SERVICE BULLETIN

Classification: BT16-025	Reference: NTB16-102	Date: October 28, 2016
-----------------------------	-------------------------	---------------------------

2016 TITAN XD; BUZZ NOISE FROM SUBWOOFER

APPLIED VEHICLE: 2016 Titan XD (A61) - Equipped with subwoofer

Figure 1

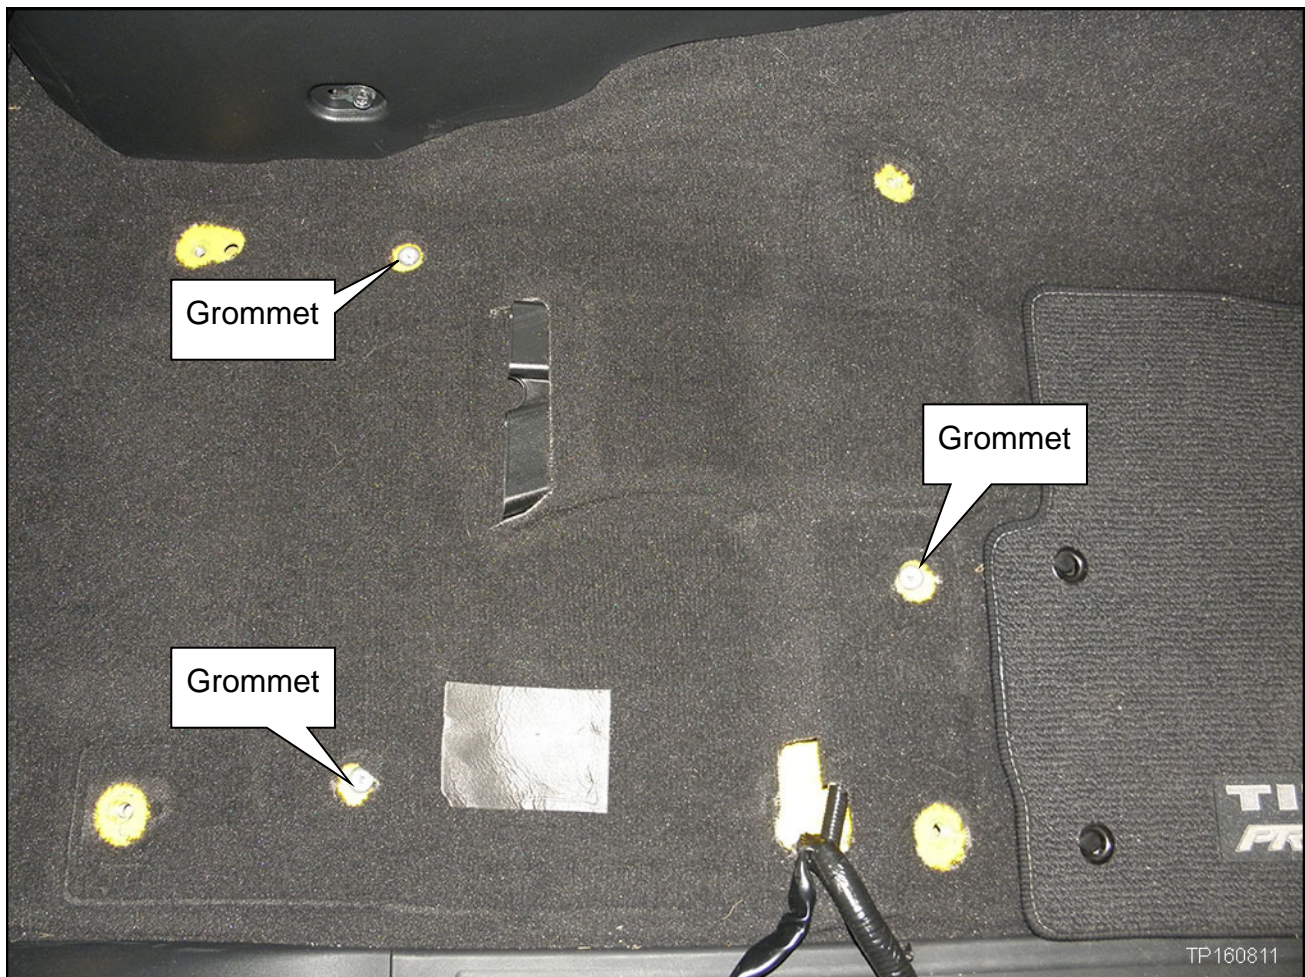
With the audio system ON, a buzz/vibration noise is coming from the subwoofer mounting points under the passenger side seat.

2. Remove the grommets shown in Figure 1.

3. Install new grommets.

- New grommets are listed in the PARTS INFORMATION section.
- To install, push them into the existing holes.

Figure 2

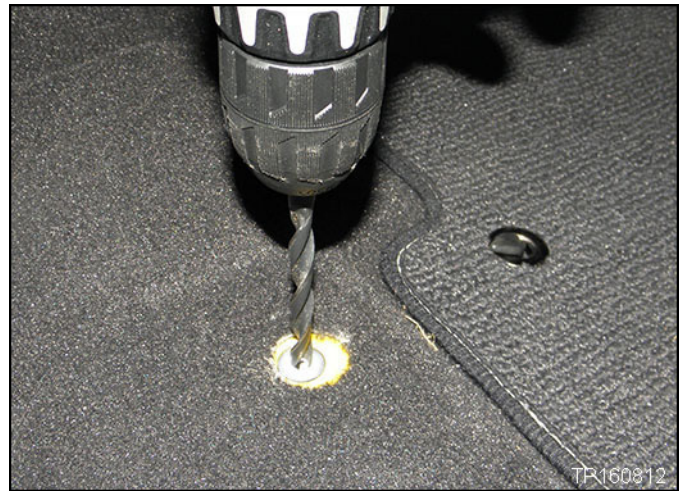
- a. Use a 5/16 drill bit to remove material from the center of each grommet.
